RE: Maryland University Training Reactor (License #R-70) responses to Request for Additional Information dated April 16, 2019

Enclosed please find the University of Maryland's responses to the 13 requests for additional information (ML19024A291) regarding the license amendment request dated the March 28, 2018 (ML18092A086).

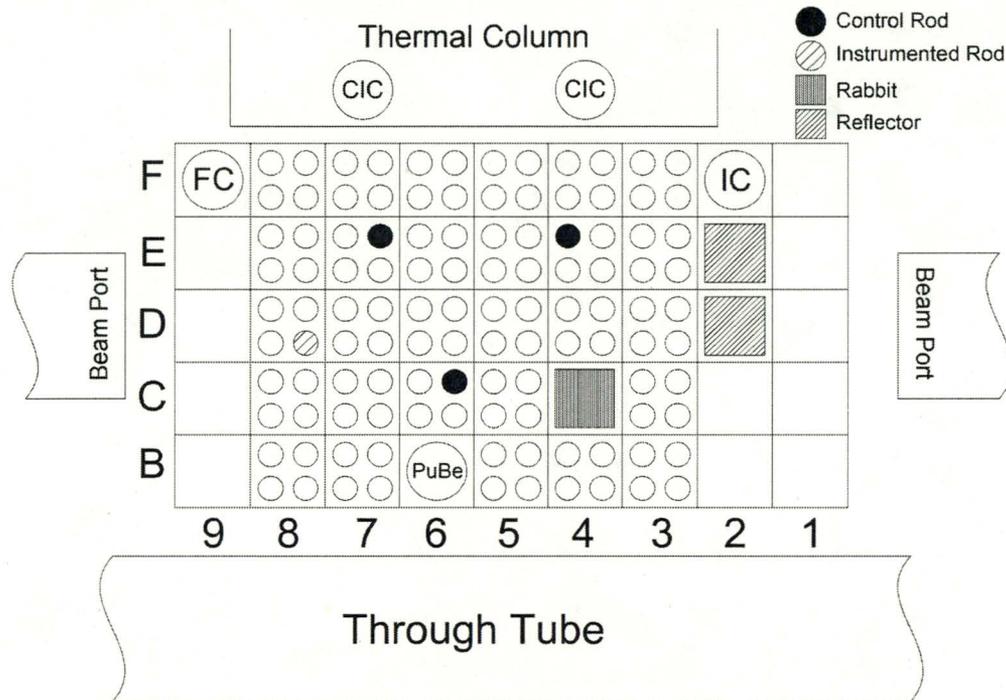
**RAI #9:** Provide an illustration of the proposed core configuration showing the locations of fuel bundles that may be displaced for the in-core pneumatic experimental system, plutonium-beryllium source, neutron detectors, and graphite reflector elements. Alternatively, justify why additional information is not necessary.

See below. Elements are displaced from grid position B6 for the plutonium-beryllium source and grid position C4 for the in-core pneumatic experimental system. Neutron detectors and graphite reflectors are located on the periphery of the core.
